Our ref: 124997-100/16/BSC/YP/jdw
Date: 17 March 2025

Proposed development at 34a Netherhall Gardens, London NW3 5TP
Responses to Objections relating to daylight, sunlight and overshadowing
Camden Council planning reference 2024/5731/P

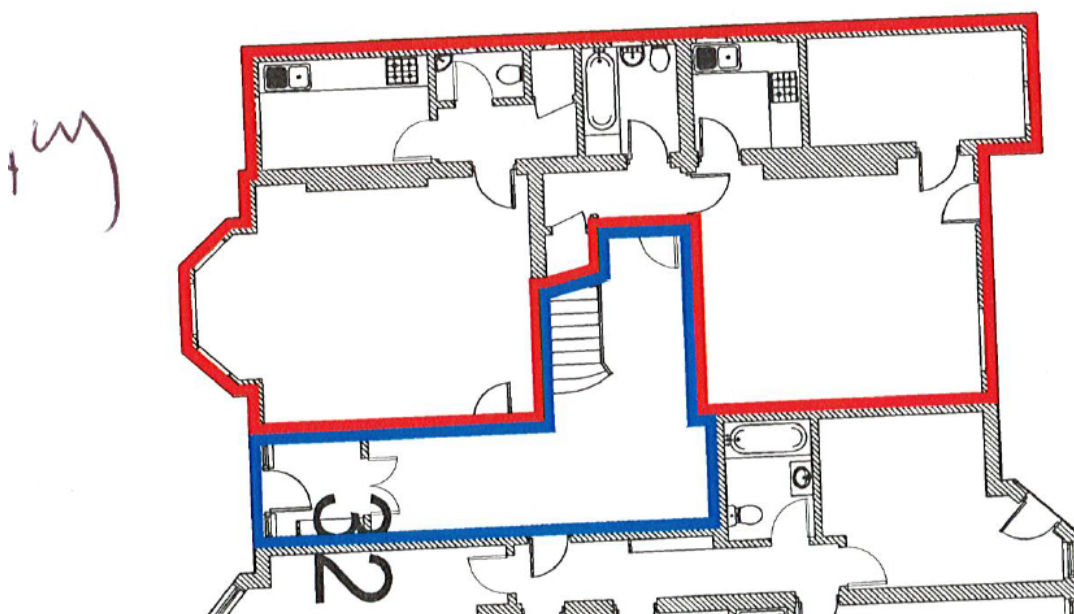
- Smith Marston were critical of the extent of the overshadowing assessment undertaken to the exterior garden of flat 8, 34 Netherhall Gardens. While we do not agree with Smith Marston's comments, we have undertaken a revised overshadowing assessment for the area to side of the garden, and the results are set out below.

Building Ref	Floor Ref	Amenity Ref	Amenity Area	Existing Lit Area	Proposed Lit Area	Existing %	Proposed %	Pr/Ex	Meets BRE Criteria
34 Netherhall Gardens	Ground	A1	77.0	41.6	34.9	54%	45%	0.84	YES

Again, despite Smith Marston's attempts to discredit our work and put undue pressure on the planning authority, it can be seen that the garden still meets the BRE target and therefore the proposal is BRE compliant in this regard too.

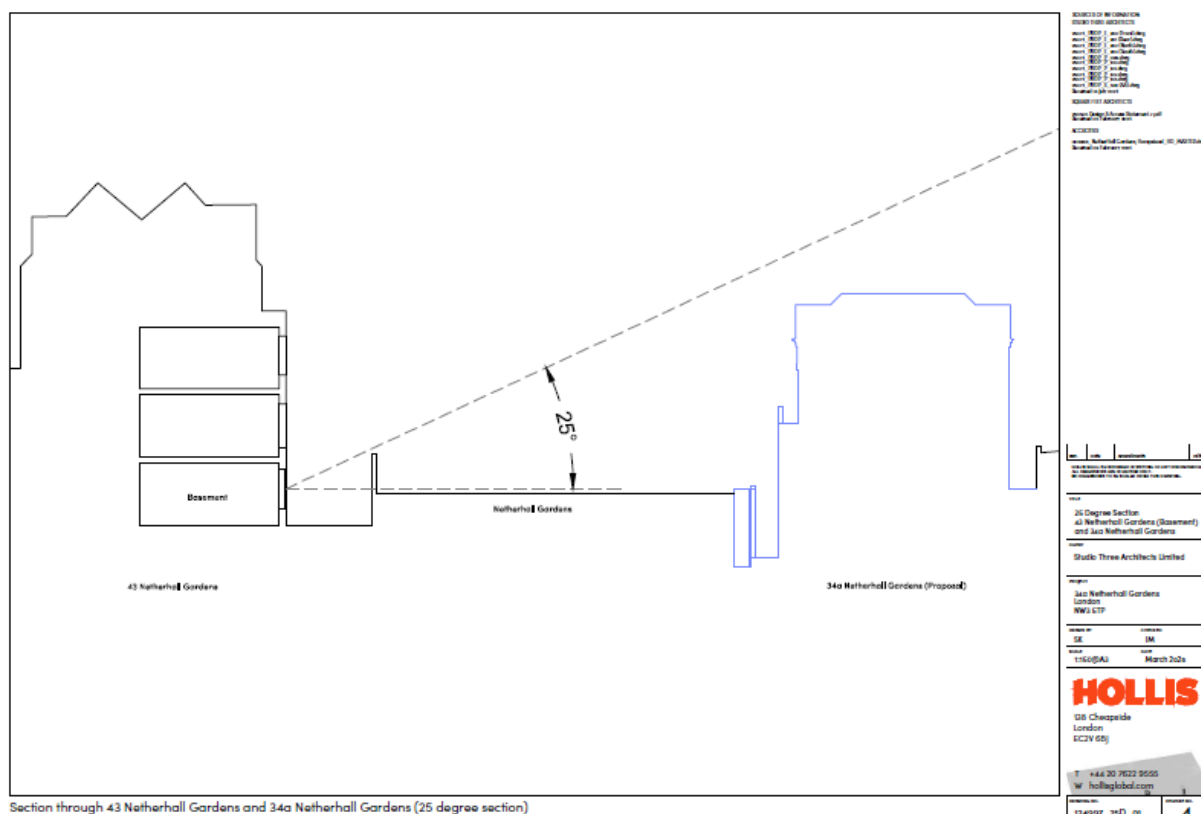
In addition to the above important factor, further research on the layout and room uses at 32 has determined that all but one of the windows on the ground floor which face the proposal serve non habitable rooms (bathrooms and a cupboard), see plan below. One window serves a small kitchen, however, this room is not considered to constitute a habitable room, due to its size which suggests it would only be used for utilitarian purposes (to prepare food etc) as it does not contain a table. Therefore it is required for utility as opposed to amenity and has a lower requirement for natural light.

In summary, with regard to 32 Netherhall Gardens, given the small reductions in light, the location of the windows close to the boundary and the room uses, we maintain that the proposals accord with the BRE guide and no material effects will be noted by the residents.
